Subject: Objection against DA 2024/1562 (5 Lauderdale Ave, Fairlight)

# DA 2024/1562 - 5 Lauderdale Avenue, Fairlight

# VISUAL IMPACT ASSESSMENT

OBJECTION to Development Application DA2024/1562 at DP 24923, No.5, Lauderdale Avenue, Fairlight.

# **VIEWPOINT 01**

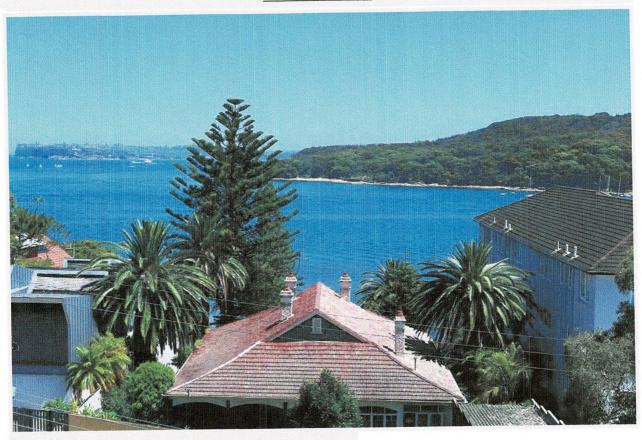
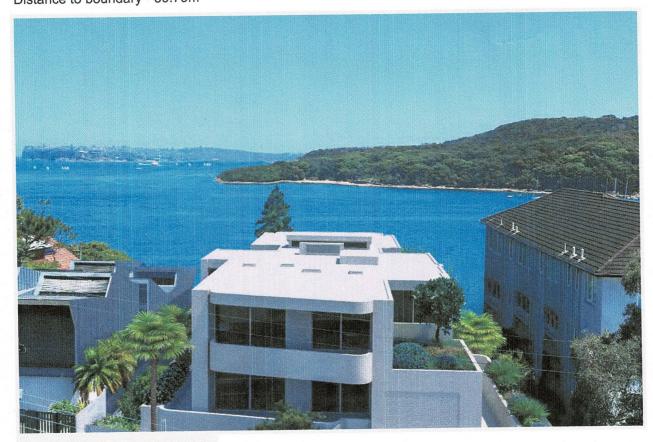
This is a static, private view from Unit 7 of 8 Lauderdale Avenue, south facing balcony, 1m back from the balustrade at standing height, facing due south towards the subject site at no.5 Lauderdale Avenue.

The foreground includes the residences along the southern side of Lauderdale Avenue and the rooftop of the subject site with large Norfolk pine bisecting the view to the harbour and multi residence apartment to the eastern side which is of a higher vertical aspect in relation to the adjacent parallel residential dwellings positioned on the same street. A wide expanse of water is visible on both sides of the large mature pine tree. To the west, the land water interface of Reef Beach and various anchored sailing vessels are observed, adjacent to Forty Baskets Beach, with the Dobroyd Head landform rising up behind, to the south. In the background, to the east of the trees, panoramic views over the harbour include the northern tip of Watsons Bay, South Head and Vaucluse.

The visual impact of the proposal will result in loss of a large area of the water element of North Harbour and a reduction in the quality of elements in the view, from natural, landscaped elements to a hard bulk and scale of the flat rooftop of the new proposal.

- · Value of view: High
- · View location: Outdoor Living Area Primary living area
- Extent of impact: Moderate-to-Severe

Reasonableness of proposal: The non-compliant upper-level mass of the proposal sits directly in front of this viewpoint, removing visual access to a significant area of the water view. As a result of the unreasonable proposal, a more skilful design should be submitted to reduce the visual impact and adhere to the Council's guidelines for view-sharing.
